APPEAL SUMMARY

Appeal ID: 21943	Project Address: 200 NW Royal Blvd, Lot #5
Hearing Date: 10/2/19	Appellant Name: Robert Oshatz
Case No.: B-006	Appellant Phone: 5036354243
Appeal Type: Building	Plans Examiner/Inspector: Jill Grenda, Nancy Thorington, Stacey Castleberry, Eric Engstrom
Project Type:	Stories: 3 Occupancy: R Construction Type: V-B
Building/Business Name: RHO LLC	Fire Sprinklers: No
Appeal Involves: Reconsideration of appeal	LUR or Permit Application No.: 06-107711-LU
Plan Submitted Option: pdf [File 1] [File 2] [File 3] [File 4] [File 5]	Proposed use: Single family residence

APPEAL INFORMATION SHEET

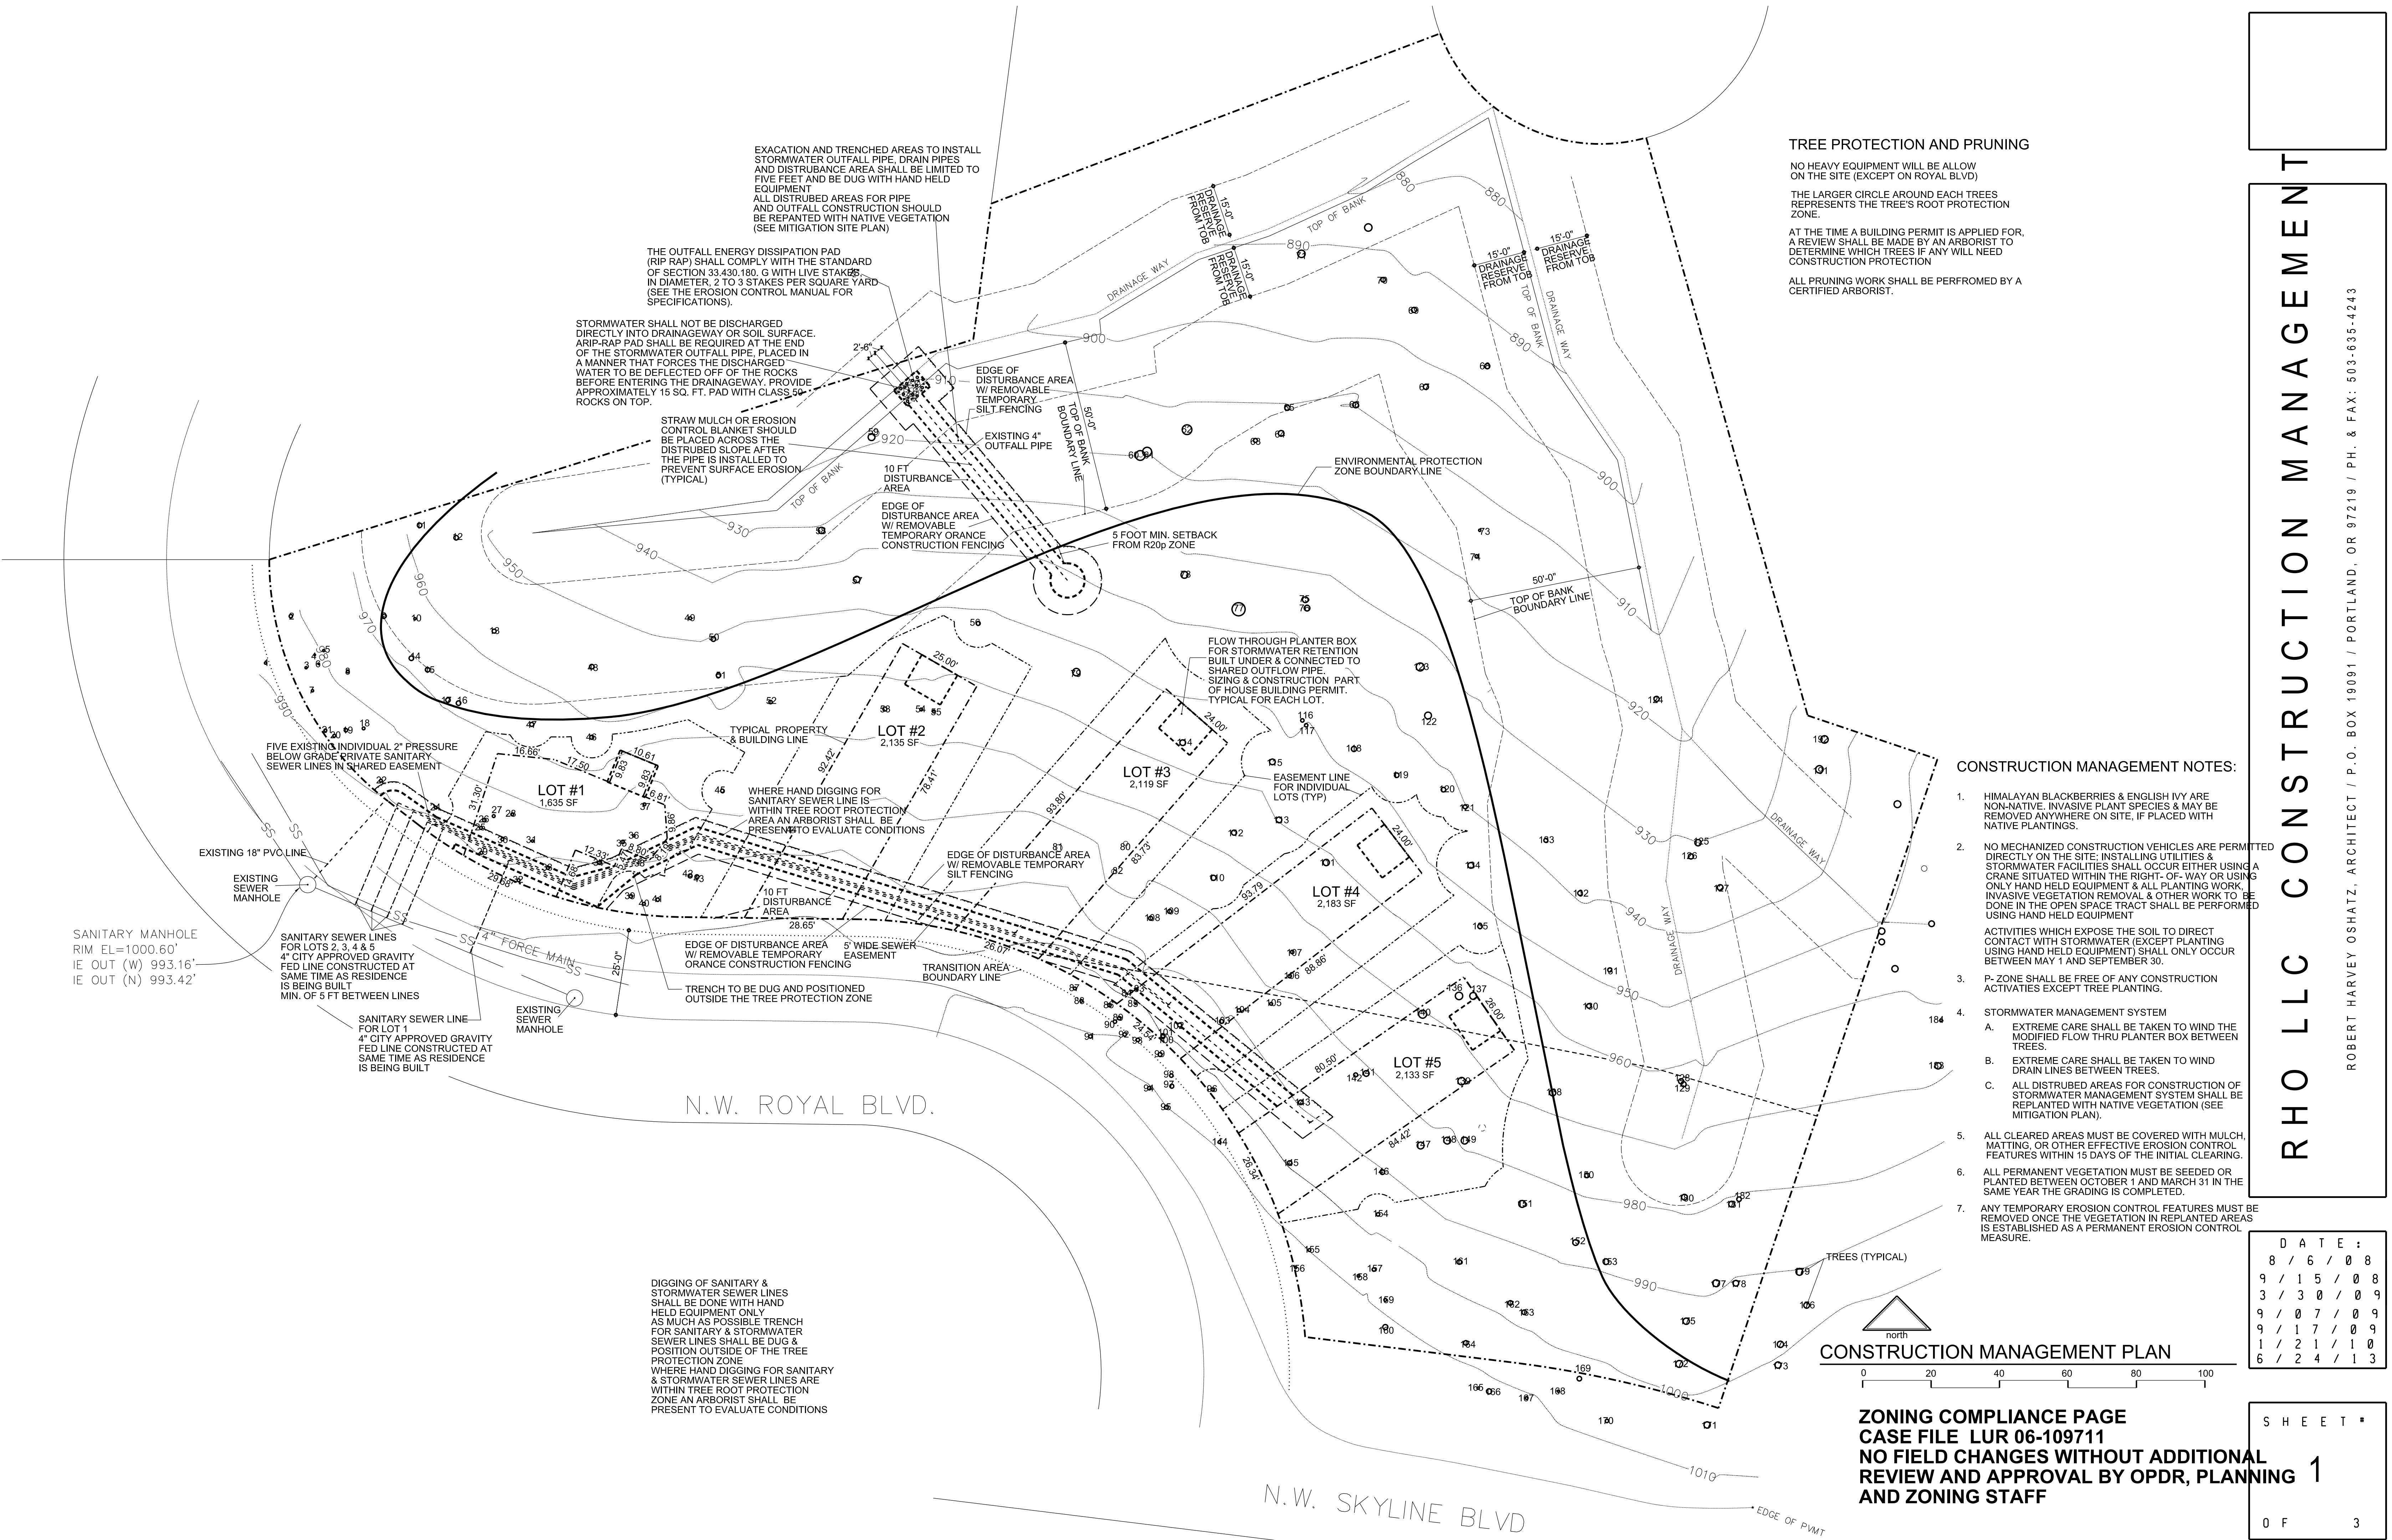
Section R302.1 of the 2005 Oregon Residential Specialty Code is concerned with public safety. It requires that openings are not permitted less than 3 feet from a property line. Essentially this results in a separation of openings between structures of at least 6 feet to prevent fire spreading. In this appeal, for Lot #4 will be at least 20 feet away from any future structure on Lot #3 and Lot #5 (as required by the subdivision approval). This is greatly exceeding the 6 feet suggested by R302.1. Thus, the design follows the intent of the code and more than satisfies it.

I feel code guide OSSC/32/#1 should not apply in this case. In the past it has been targeted for cantilevering into public common areas that is used by the public. This is a case where the structure is cantilevering into its own privately not open to the public green space. When the subdivision is look at with its private common green space (which is not open to use by the public and since the site is steeply sloping and the structures are not design for their occupants to use the private common green space) in essence the house is meeting the concerns of a residence built in a R20 zone. In reality except to meet zoning requirements of an environmentally sensitive site the property lines are imaginary (in essence the planning department is saying this by going along with the concept of cantilevering over the property lines and requiring the residence to be a minimum of 2,000 sf).

The cantilever deck which will be constructed of steel beams, 4x14 joist and 2x6 outdoor decking; the roof will be Class B materials, the walls are cad in sheet-metal, wood and stucco and soffits will be 5/8" fire rated gypsum board; making the structure at least as safe as any other residence in the neighbor. In addition, I am willing to work with the Fire Marshall's office to mitigate any of their concerns.

Openings in exterior walls at property line: Granted as proposed.

The Administrative Appeal Board finds that the information submitted by the appellant demonstrates that the approved modifications or alternate methods are consistent with the intent of the code; do not lessen health, safety, accessibility, life, fire safety or structural requirements; and that special conditions unique to this project make strict application of those code sections impractical.
